RESPONSES TO CEC COMMENTS ON THE
MODELING PROTOCOL SUPPLEMENT FOR
THE HYDROGEN ENERGY CALIFORNIA
(HECA) PROJECT

Revised Application for Certification (08-AFC-8)

March 20, 2012

Technical Area: Air Quality

**Wind Roses for Bakersfield Meadows Field Airport (2006–2010),
Fellows, California (2004–2008), and
Missouri Triangle (2004–2008)**

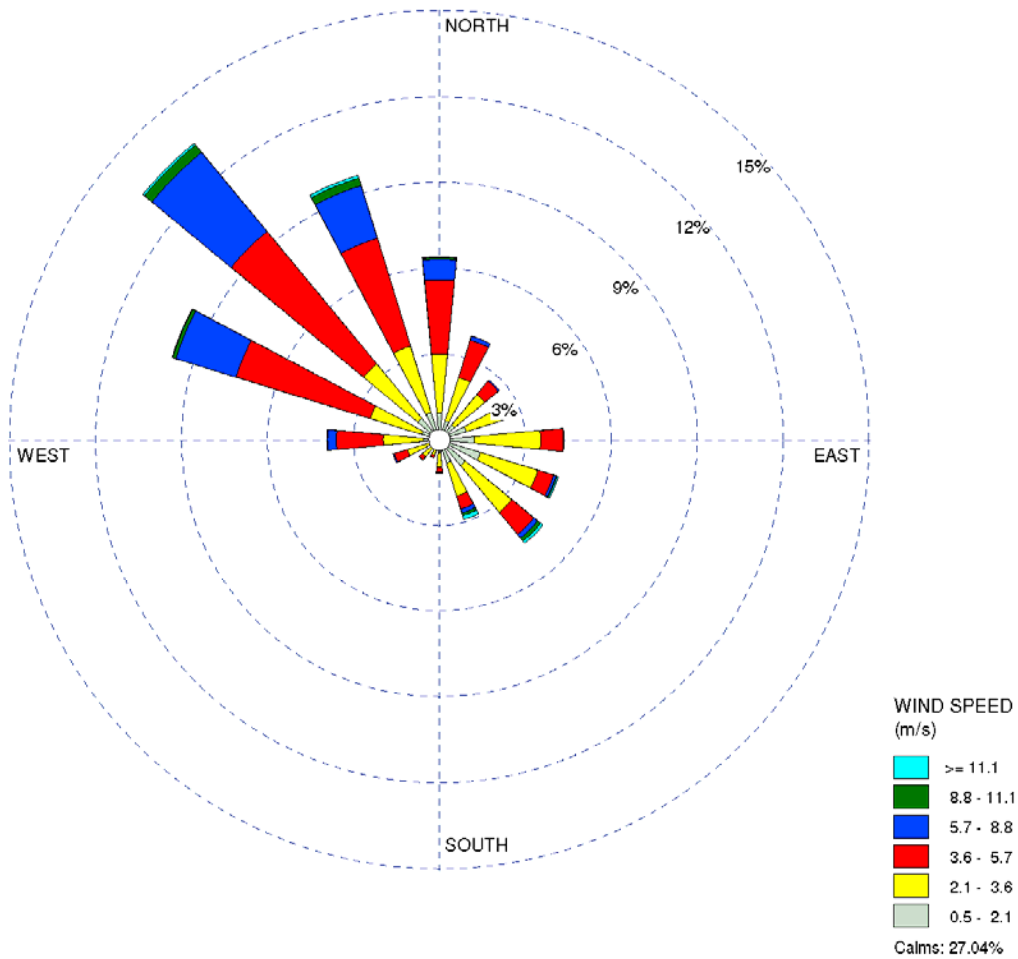
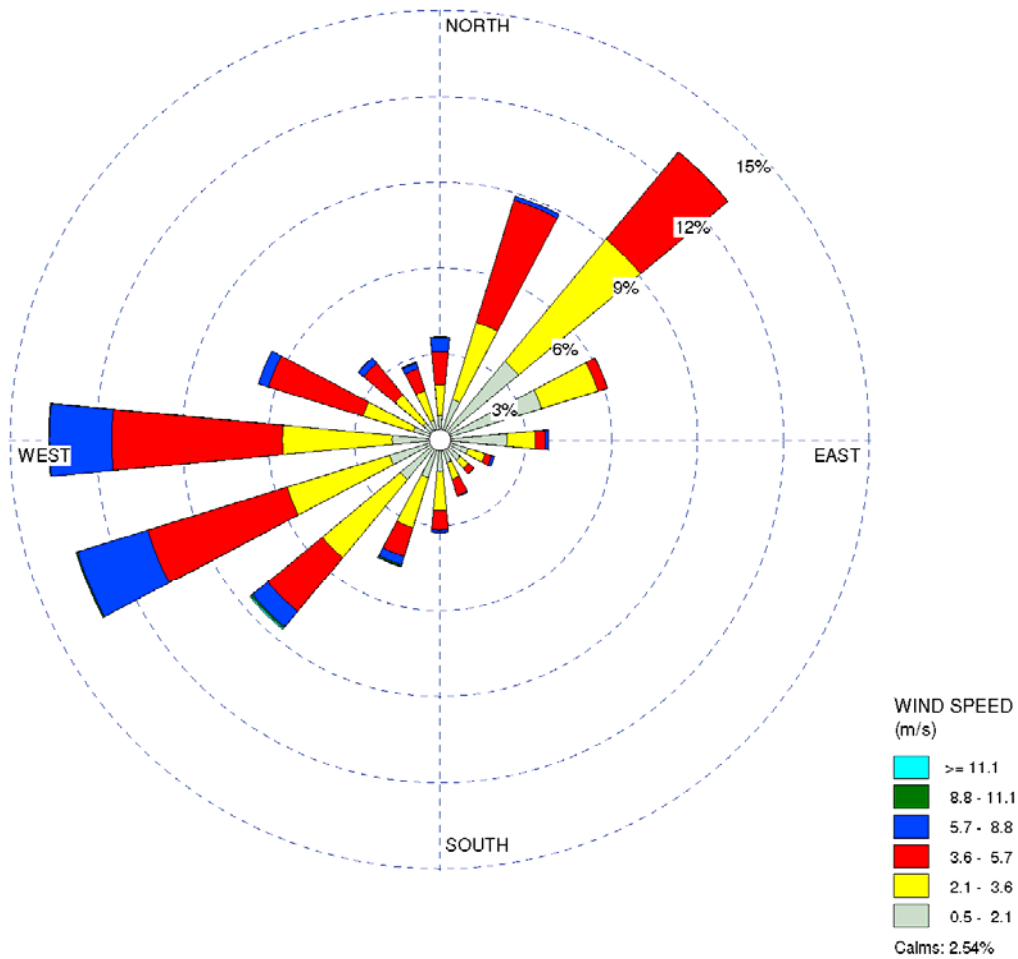
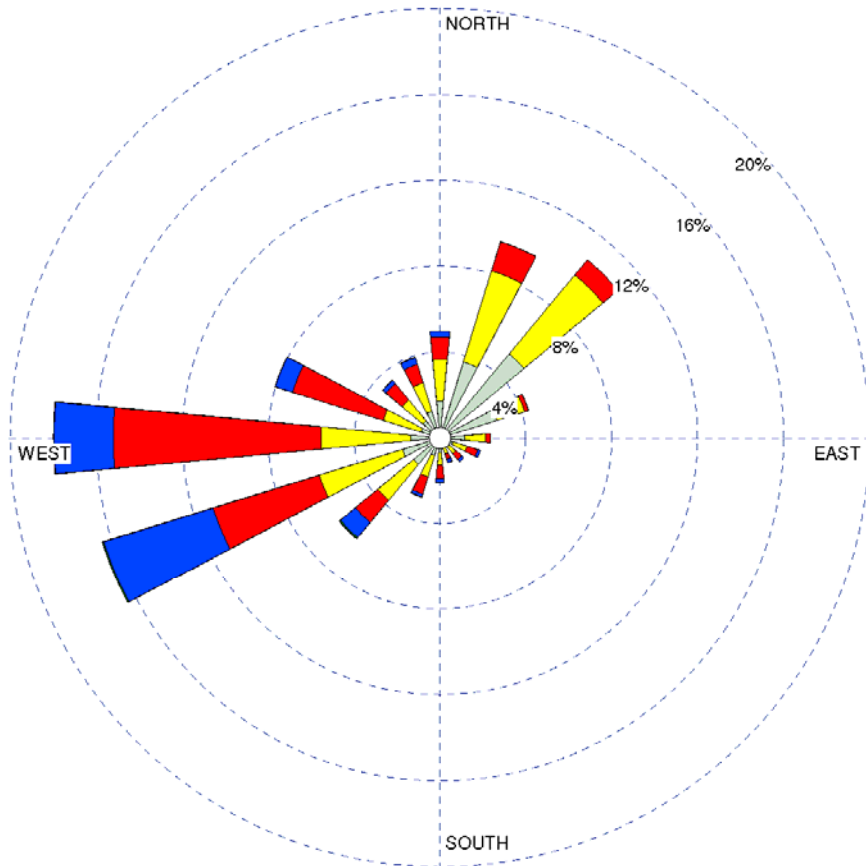
4. ***Page 9 – Meteorological data selection. It is understood given SJVAPCD modeling guidance why the Bakersfield meteorological data was selected for the criteria pollutant modeling analysis, but there is MM5 derived meteorological data from the west side of air basin that could be used for the HRA modeling. Please discuss why this data isn't being used and identify if SJVAPCD was consulted about the use of this data for the HRA and the results of that consultation.***

SJVAPCD was consulted, and they provided meteorological data to be used for all dispersion modeling analyses using the American Meteorological Society/Environmental Protection Agency Regulatory Model (AERMOD), including both Ambient Air Quality Standards and Health Risk Assessment (HRA) modeling. SJVAPCD processed and provided to HECA the data from the most representative meteorological station, the Bakersfield airport, for the five most recent available meteorological years. HRA modeling will use AERMOD and Hotspots Analysis and Reporting Program (HARP) On-Ramp with the same meteorological data set used for the criteria pollutant modeling analyses for consistency with the analyses that will be conducted by SJVAPCD in review of the air permit. SJVAPCD has provided hourly meteorological data that pair in time with the hourly background ozone and nitrogen dioxide data for 2006–2010. This is the most recent 5-year data set available for all parameters needed. HECA will be using these years of data for all modeling analyses.

To determine the most representative meteorological station, SJVAPCD and HECA considered many factors. The HECA Project is situated in a valley at a base elevation of 87 meters. The Bakersfield airport station is 20 miles away and is also situated in the valley, with an elevation of 149 meters. However, sites on the west side of the air basin that use the MM5 data for the basis of the data set are at Missouri Triangle and Fellows, both upslope in the hills west of the HECA Project Site, at base elevations of 268 meters and 472 meters, respectively. Temperatures would generally be cooler in the hills, and wind patterns are not as representative at these stations as at the Bakersfield airport station, which is situated in the valley, as is the HECA Project Site.

Attachment 4-1 presents wind roses for a comparison of wind speed and direction at Bakersfield Meadows Field Airport, Fellows, and Missouri Triangle stations for the most recent 5-year periods at each site. The wind directional patterns differ more in the valley than in the hills; therefore, the most representative meteorological data from the Bakersfield station will be used for the criteria pollutant and HRA modeling.
